**Validation report form for renewal of crediting period for
CDM project activities
(Version 03.0)**

Title and UNFCCC reference number of the project activity	Joburg Landfill Gas to Energy Project UNFCCC No: 6797
Number and duration of the next crediting period	2– Seven Years (12/11/2019 to 11/11/2026)
Version number of the validation report	1.3
Completion date of the validation report	02/12/2020
Version number of PDD to which this report applies	12
Project participants	ENER-G Systems Joburg (PTY) Ltd.
Host Party	Republic of South Africa
Applied methodologies and standardized baselines	ACM0001: Flaring or use of landfill gas - Version 19.0. ASB0040-2018 Standardized baseline: Grid emission factor for Southern African Power Pool, version 1.
Mandatory sectoral scopes	Sectoral Scope 13: Waste handling and disposal
Conditional sectoral scopes	Sectoral Scope 1: Energy industries (renewable - / non-renewable sources)
Estimated amount of annual average GHG emission reductions or GHG removals by sinks in the next crediting period	480,155 tCO ₂ e

“Joburg Landfill Gas to Energy Project”

Diagram A-1: Project activity set-up

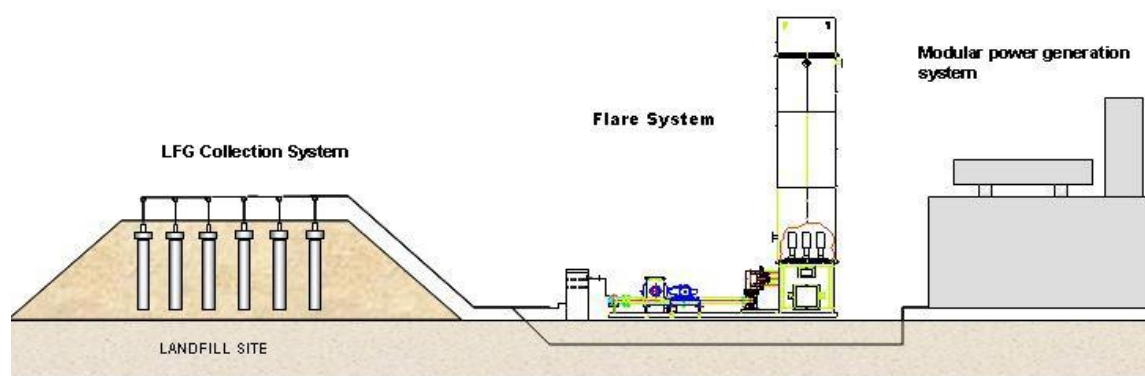
1. The definition of the project boundary has been provided in B.3.
2. The format of the table in B.3 has been revised so that is consistent with the methodology.
3. The flow diagram has been revised so that it includes reference to the Southern African Power Pool grid.

1. The definition of the project boundary was added and found applicable to the project.
2. The format of the table used was revised and is consistent with applied versions of methodology and PDD template.
3. The flow diagram or project set-up was revised including SAPP and found complete.
